Technical Bulletin

TB 0297A– Current transformers in Siemens 8DJH circuit breaker units

Fig. 2 Installed blue colour CTs (post-February 2020)

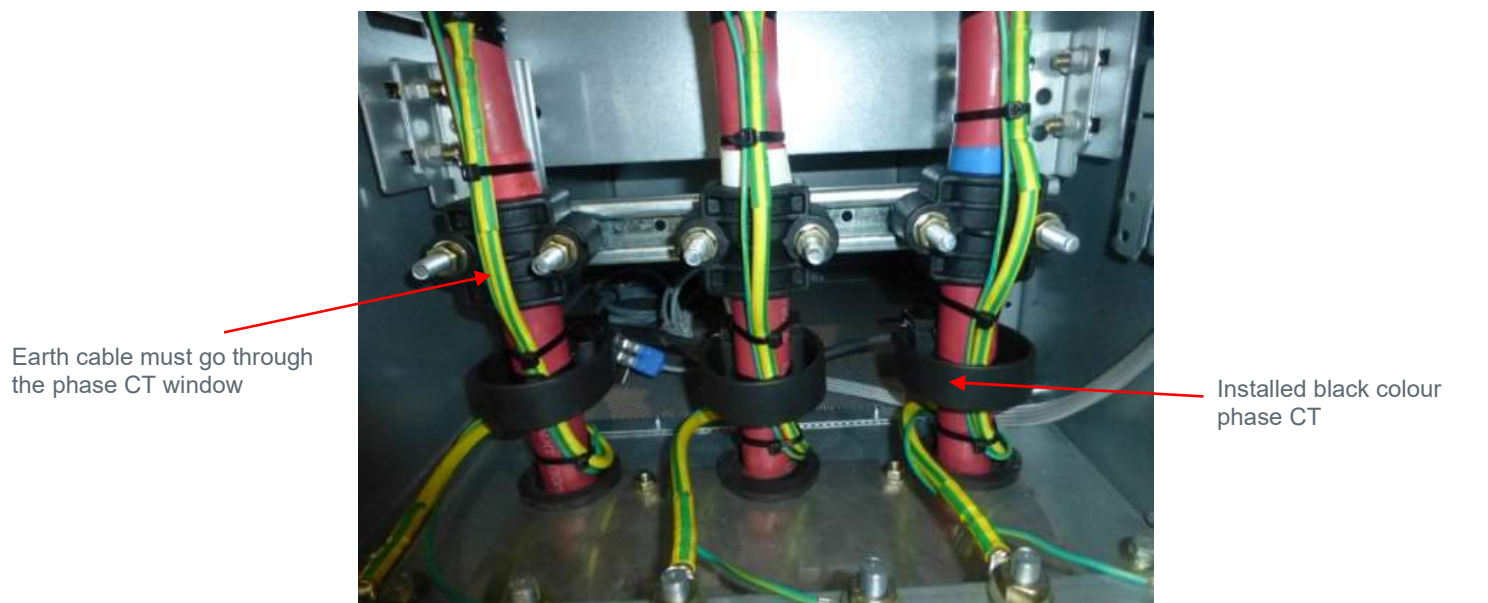
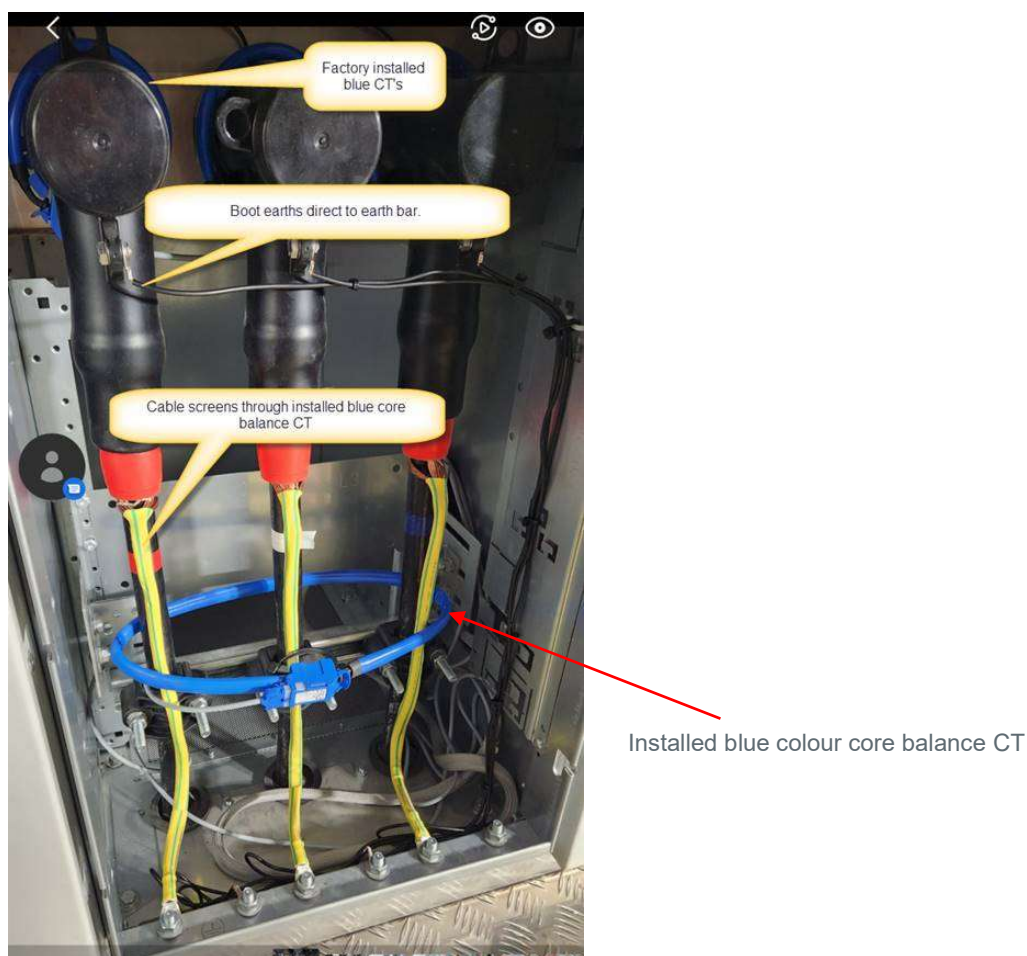
Initial supply of circuit breaker units was supplied with a black colour CT that need to be fitted during assembly of the cable tail and the core balanced CT was not used. (Refer to Fig. 1)

Effective February 2020, all circuit breakers units are supplied with factory fitted blue colour CTs and an unfitted large core balanced blue colour CT. The core balance CT is used to detect earth faults. The core balanced blue colour CTs used in a RL, RLR & RLRR switchgear must be installed in accordance to Figure 2 and the manufacturer's instructions. It is important that the earth cable run through the core balance CT window as shown in Figure 2.

Please confirm the cable ties are securely fitted during installation. If the cable ties are

unsatisfactory, utilise standard cable ties from the stores (stock code: ST16250).

CT's must be checked to be secured prior to commissioning and shall be inspected during routine maintenance.
